Proposal for amendments to global technical regulation No. 9

Submitted by the expert from Japan*

The text reproduced below was prepared by the expert from Japan in order to propose the use of the Flexible Pedestrian Legform Impactor (FlexPLI) in the global technical regulation (gtr) No. 9 (pedestrian safety). It is based on ECE/TRANS/WP.29/GRSP/2009/21 and on a document without symbol (GRSP-46-17/Rev.1) distributed during the forty-sixth session of the Working Party on Passive Safety (GRSP). The modifications to the current text of the gtr No. 9 on pedestrian safety are marked in bold or strikethrough characters.

Figure 13: FlexPLI; Dimensions and C.G. locations of femur, knee joint, and tibia (Side view)

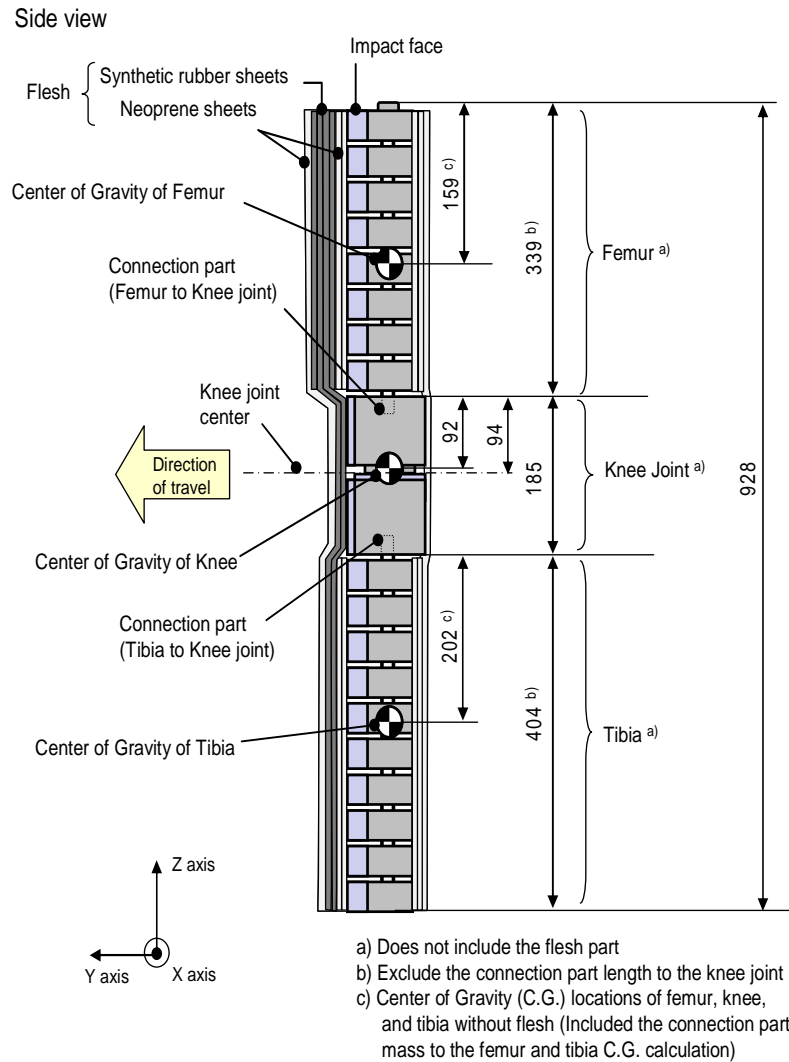
The lower legform impactor shall consist of flesh, flexible long bone segments (representing femur and tibia), and a knee joint as shown in Figure 13.

The overall length of the impactor shall be 928 ± 3 mm, having a required mass of 13.2 ± 0.7 kg including flesh. The length of the femur, knee joint, and tibia shall be 339 ± 2 mm, 185 ± 1 mm, and 404 ± 2 mm respectively. The knee joint centre position shall be 94 ± 1 mm from the top of the knee joint.

The centre of gravity of the femur and tibia without flesh, including the connection part to the knee joint, shall be 159 ± 8 mm and 202 ± 10 mm respectively from the top, but not including the connection part to the knee joint, of each part as shown in Figure 13. The centre of gravity of the knee shall be 92 ± 5 mm from the top of the knee joint as shown in Figure 13.

Figure 14: FlexPLI; femur, tibia, and knee dimensions (Top view)

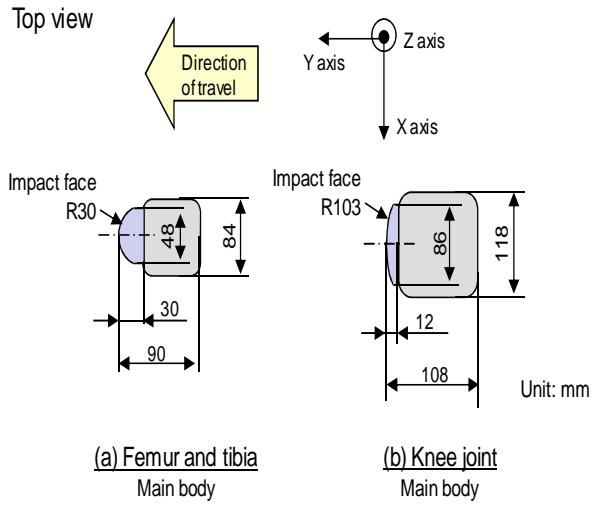
6.3.1.2.1. The cross-sectional shape perpendicular to the Z axis of the femur and tibia main bodies shall be 90 ± 2 mm in width along the Y axis, and 84 ± 1 mm in width along the X axis as shown in Figure 14 (a). The impact face shall be 30 ± 1 mm in radius, 30 ± 1 mm in width along the Y axis, and 48 ± 1 mm in width along the X axis as shown in Figure 14 (a).

6.3.1.2.2. The cross-sectional shape perpendicular to the Z axis of the knee joint shall be 108 ± 2 mm in width along the Y axis, and 118 ± 1 mm in width along the X axis as shown in Figure 14 (b). The impact face shall be 103 ± 1 mm in radius, 12 ± 1 mm in width along the Y axis, and 86 ± 1 mm in width along the X axis as shown in Figure 14 (b).

Figure 15: FlexPLI; flesh dimensions

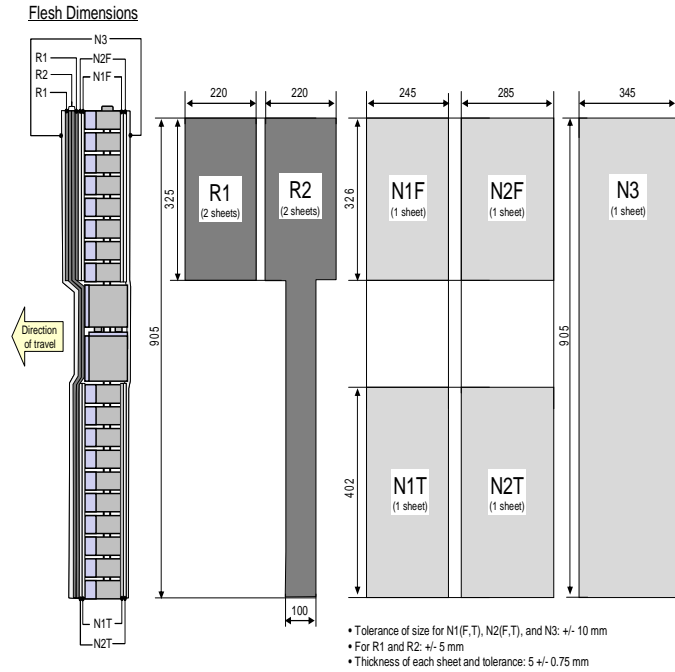
6.3.1.2.4. For each test, the impactor (femur, knee joint, and tibia) shall be covered by flesh composed of synthetic rubber sheets (R1, R2) and neoprene sheets (N1F, N2F, N1T, N2T, N3) as shown in Figure 15. The sheets are required to have a compression characteristic as shown in Figure 16. The compression characteristic shall be checked using the same batch of

Figure 16: FlexPLI; flesh compression characteristics

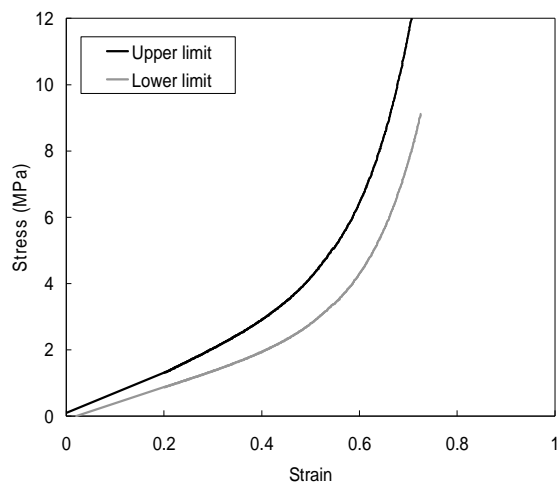
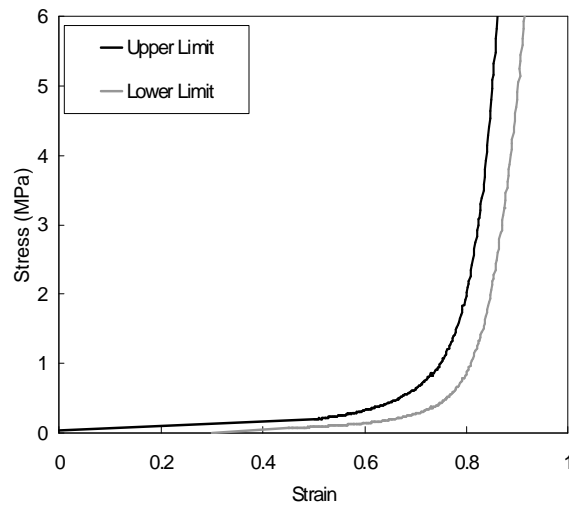
sheets as those used for the impactor flesh. The size of the sheets shall be within the requirements described in Figure 16.

Figure 17: FlexPLI; instrument locations”

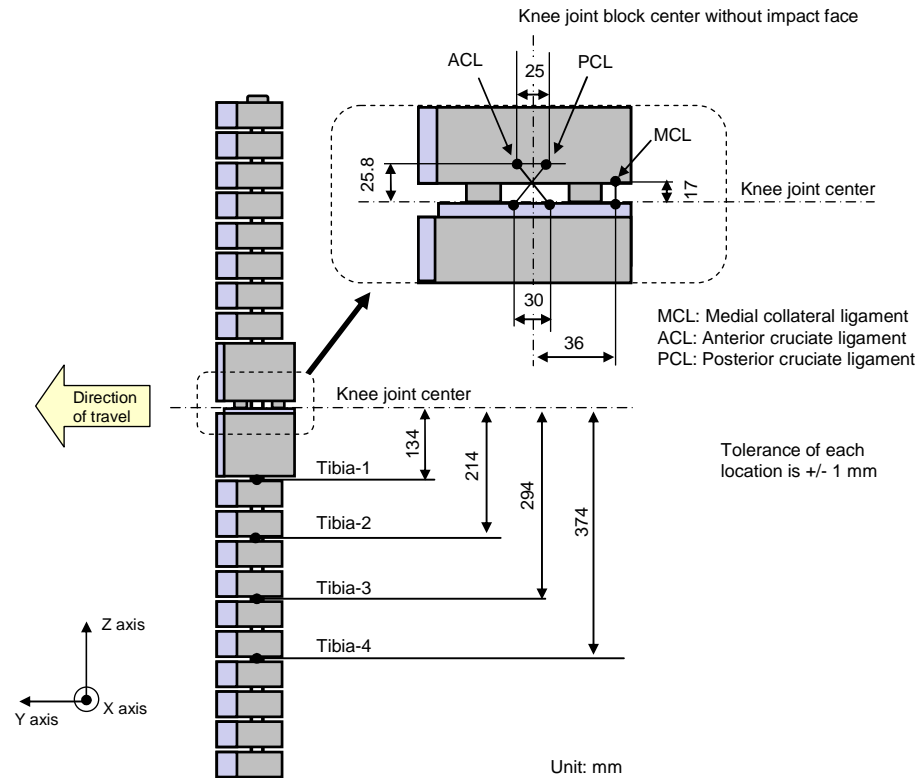
- 6.3.1.2.6. Lower legform instrumentation
- 6.3.1.2.6.1. Four transducers shall be installed in the tibia to measure bending moments applied to the tibia. The sensing locations of each of the transducers are as follows: tibia-1: 134 ± 1 mm, tibia-2: 214 ± 1 mm, tibia-3: 294 ± 1 mm, and tibia-4: 374 ± 1 mm below the knee joint centre respectively as shown in Figure 17. The measurement axis of each transducer shall be the X axis of the impactor.

- 6.3.1.2.6.2. Three transducers shall be installed in the knee joint to measure elongations of the medial collateral ligament (MCL), anterior cruciate ligament (ACL), and posterior cruciate ligament (PCL). The measurement locations of each transducer are shown in Figure 17. The measurement locations shall be within ± 3 mm along the X axis from the knee joint centre.

Figure 23: Tolerances of angles for the lower legform impactor at the time of the first impact (see paragraphs 7.1.2.2. and 7.1.2.3.2.)

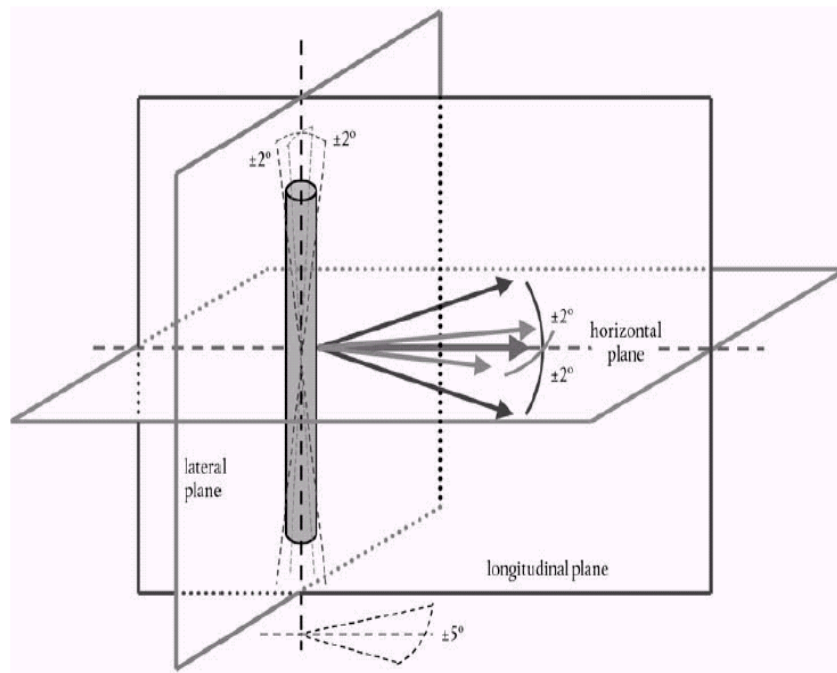
7.1.2.2. **The direction of the impact velocity vector shall be in the horizontal plane and parallel to the longitudinal vertical plane of the vehicle. The tolerance for the direction of the velocity vector in the horizontal plane and in the longitudinal plane shall be $\pm 2^\circ$ at the time of first contact. The axis of the impactor shall be perpendicular to the horizontal plane, with a roll and pitch angle tolerance of $\pm 2^\circ$ in the lateral and longitudinal plane. The horizontal, longitudinal and lateral planes are orthogonal to each other (see Figure 23).**

- 7.1.2.3.2. At the time of first contact the impactor shall have the intended orientation about its vertical axis, for the correct operation of its knee joint, with a yaw angle tolerance of $\pm 5^\circ$ (see Figure 23).
- 7.1.2.3.3. At the time of first contact the centre line of the impactor shall be within a ± 10 mm tolerance to the selected impact location.
- 7.1.2.3.4. During contact between the impactor and the vehicle, the impactor shall not contact the ground or any object which is not part of the vehicle.
- 7.1.2.4. The impact velocity of the impactor when striking the bumper shall be 11.1 ± 0.2 m/s. The effect of gravity shall be taken into account when the impact velocity is obtained from measurements taken before the time of first contact.”

Figure 24: FlexPLI to bumper tests for complete vehicle in normal ride attitude (left) and for cut-body mounted on supports (right) (see paragraph 7.1.2.3.)

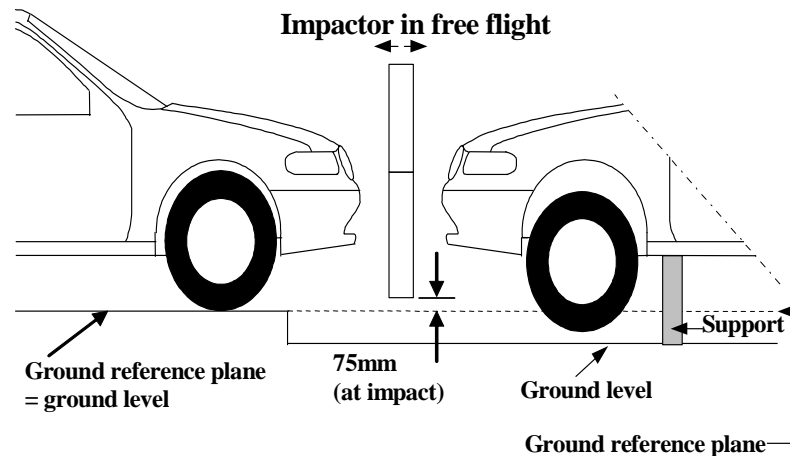
7.1.2.3. **The bottom of the impactor shall be at 75 mm above ground reference plane at the time of first contact with the bumper (see Figure 24), with a ± 10 mm tolerance. When setting the height of the propulsion system, an allowance must be made for the influence of gravity during the period of free flight of the impactor.**

Figure 31: Requirement corridor of femur and tibia in static certification test (see paragraph 8.2.1.2.)

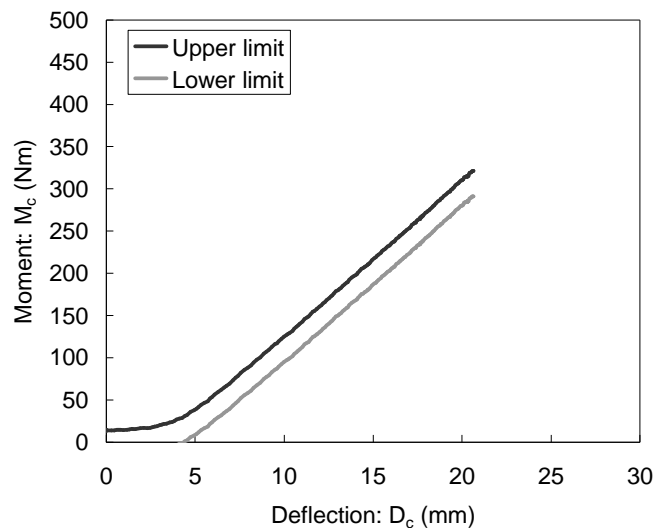
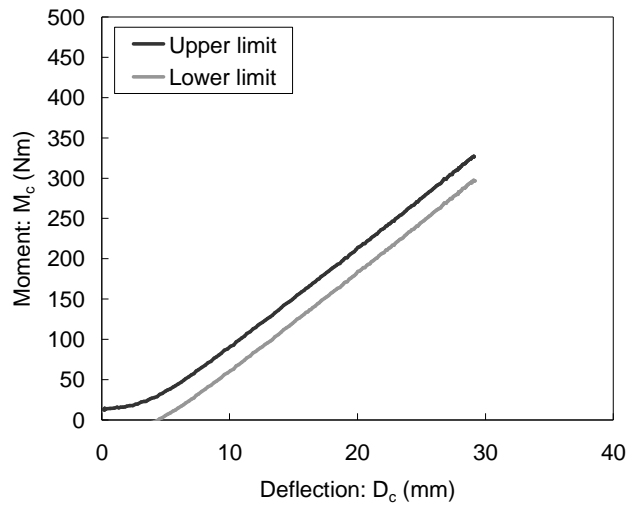
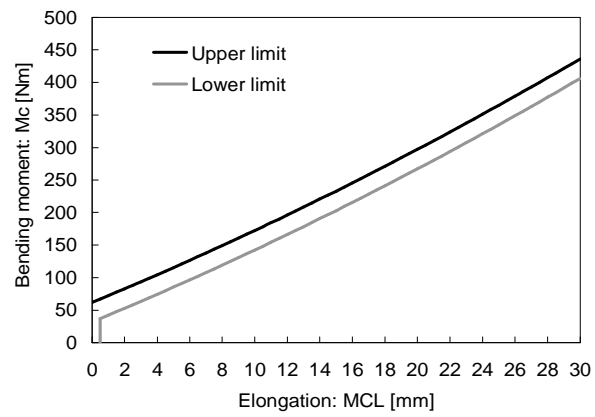
8.2.1.2. When the femur and tibia of the impactor are loaded in bending in accordance with paragraph 8.2.1.4., the applied moment and generated deflection at the centre of the femur and tibia (M_c and D_c) shall be within the corridors shown in Figure 31.

Figure 32: Requirement corridors for knee joint in static certification test (see paragraph 8.2.1.3.)

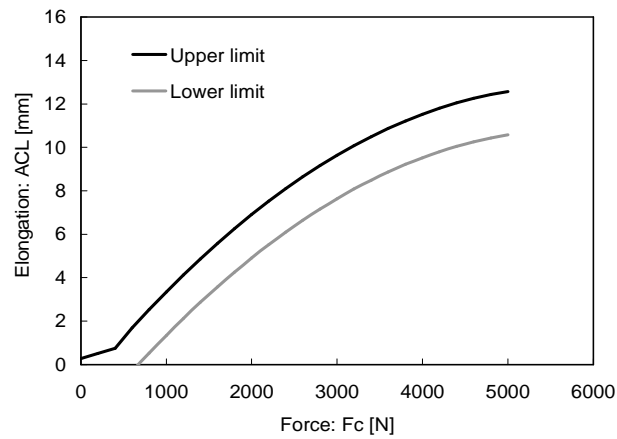
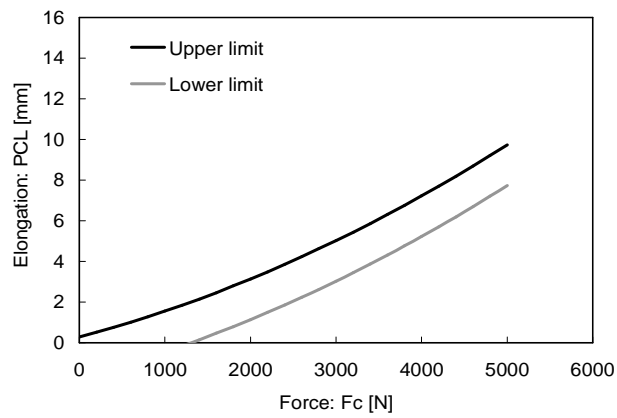
8.2.1.3. When the knee joint of the impactor is loaded in bending in accordance with paragraph 8.2.1.5., the MCL, ACL, and PCL elongations and applied bending moment or force at the centre of the knee joint (M_c or F_c) shall be within the corridors shown in Figure 32.

Figure 33: Test set-up for femur in static certification tests (see paragraph 8.2.1.4.)

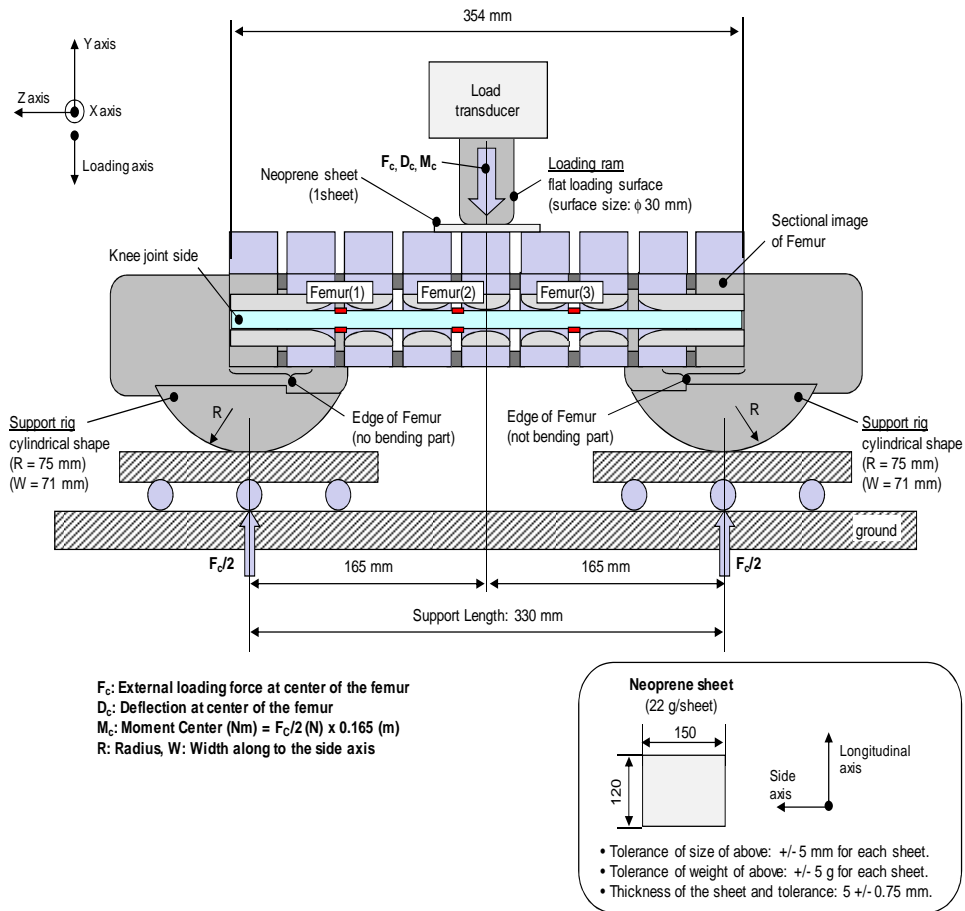
8.2.1.4. The edges of the femur and tibia, not bending parts, shall be mounted to the support rig firmly as shown in Figure 33. The Y axis of the impactor shall be parallel to the loading axis within $180 \pm 2^{\circ}$ tolerance. In order to avoid friction errors, roller plates shall be set underneath the support rigs. To avoid impactor damage, a neoprene sheet shall be set underneath the loading ram. The neoprene sheet used in this test shall have compression characteristics as shown in Figure 16.

The centre of the loading force shall be applied at the centre of the femur and tibia within $\pm 2^{\circ}$ tolerance along the Z axis. The force shall be increased at a rate between 10 and 100 mm/minute until the bending moment at the centre part (M_c) of the femur or tibia reaches [340] Nm.

Figure 35: Test set-up for knee joint in static certification test (see paragraph 8.2.1.5.)

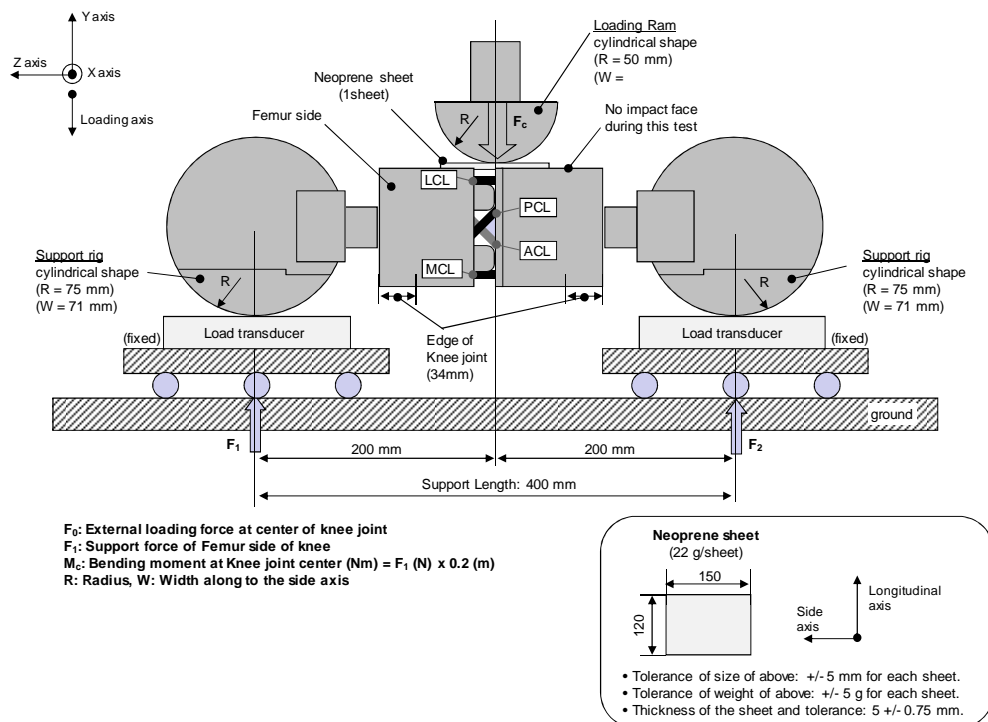
8.2.1.5. The edges of the knee joint, not bending parts, shall be mounted to the support rig firmly as shown in Figure 35. The Y axis of the impactor shall be parallel to the loading axis within $180 \pm 2^{\circ}$. In order to avoid friction errors, roller plates shall be set underneath the support rigs. To avoid impactor damage, a neoprene sheet shall be set underneath the loading ram and the impactor face of the knee joint which is described in the Figure 14 shall be removed. The neoprene sheet used in this test shall have compression characteristics as shown in Figure 16.

The centre of the loading force shall be applied at the centre of the knee joint within $\pm 2^{\circ}$ tolerance along the Z axis. The external load shall be increased at a rate between 10 and 100 mm/minute until the bending moment at the centre part of the knee joint (M_c) reaches 300 Nm.

Figure 36: Test set-up for dynamic lower legform impactor certification test, Pendulum type (see paragraph 8.2.2.4).

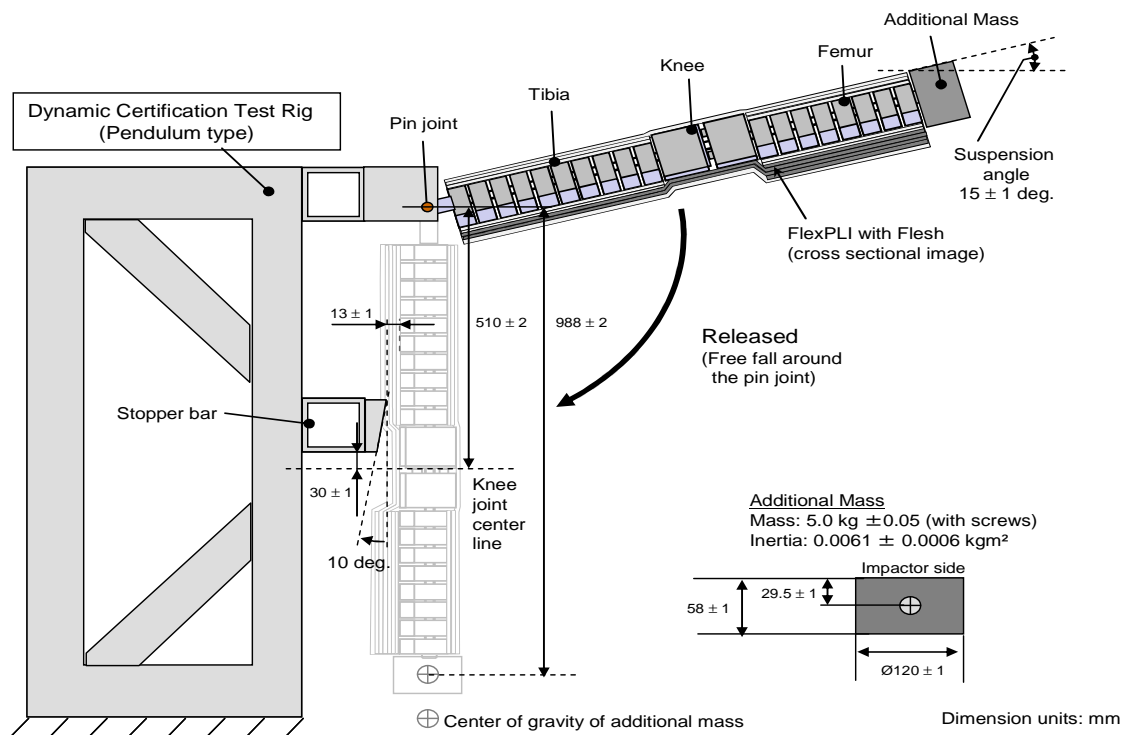
- 8.2.2.4. Test procedure
- 8.2.2.4.1. The impactor, including flesh, shall be suspended from the dynamic certification test rig $15 \pm 1^\circ$ upward from the horizontal as shown in Figure 36. The impactor shall be released from the suspended position, whereupon the impactor falls freely against the pin joint of the test rig as shown in Figure 36.

- 8.2.2.4.2. The knee joint centre of the impactor shall be 30 ± 1 mm below the bottom line of the stopper bar, and the tibia impact face shall be located 13 ± 1 mm from the front upper edge of the stopper bar when the stopper block is removed from the stopper bar and then hung from the impactor without any contact (see Figure 36).

Figure 37: Test set-up for dynamic lower legform impactor certification test, Inverse type (see paragraph 8.2.3.4)."

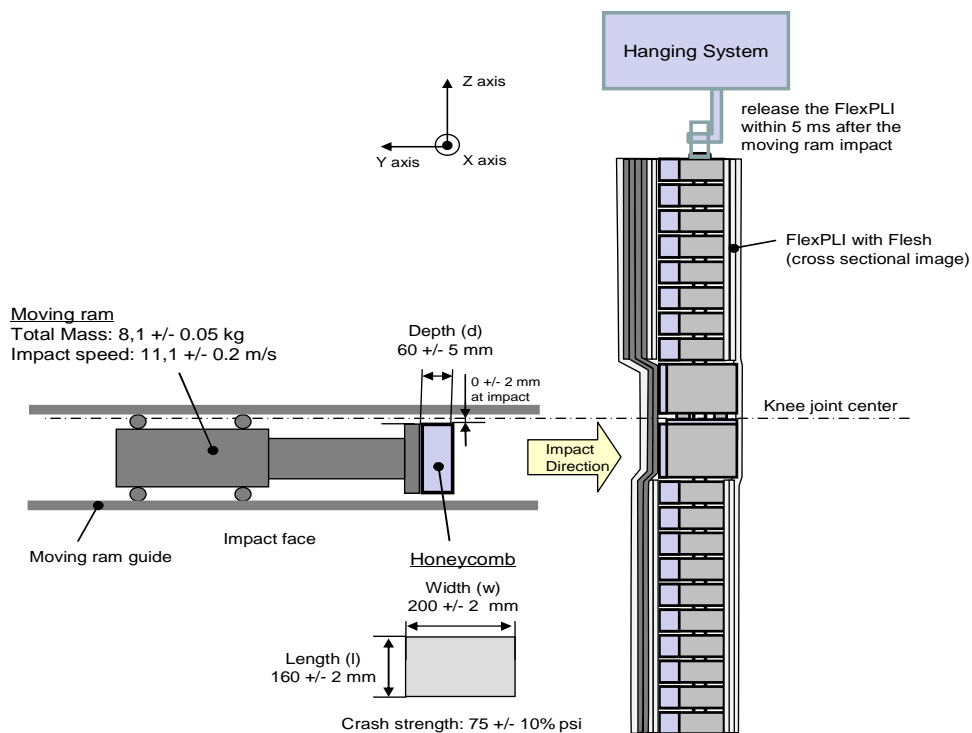
- 8.2.3.4. Test procedure
- 8.2.3.4.1. The fully assembled FlexPLI (with flesh and skin) shall be stationary suspended vertically from a test rig as shown in Figure 37. It is then impacted by the upper edge of a linearly guided Al honeycomb impactor, covered by a thin (less than 1 mm thickness) paper cloth, at an impact speed of $11,1 \pm 0,2$ m/s. The legform is to be released from the test rig within 5 ms after the time of first contact to ensure a free flight condition.

- 8.2.3.4.2. The honeycomb of 5052 alloy, which is attached in front of the moving ram, shall have a crash strength of 75 ± 10 per cent psi and dimensions of $l=200\pm 2$ mm, $w = 160 \pm 2$ mm and $d = 60 \pm 5$ mm. To ensure a consistent and good level of repeatability, the honeycomb should either have a 3/16 inches cell size in combination with a density of 3.1 pcf or a 1/4 inches cell size in combination with a density of 2.3 pcf or a 3/16 inches cell size in combination with a density of 2.0 pcf.

- 8.2.3.4.3. The upper edge of the honeycomb face is to be in line with the rigid plate of the linearly guided impactor. At time of first contact, the upper edge of the honeycomb is to be in line with the knee joint centre line within a vertical tolerance of 0 ± 2 mm. The honeycomb shall not be excessively handled or deformed before the impact test.
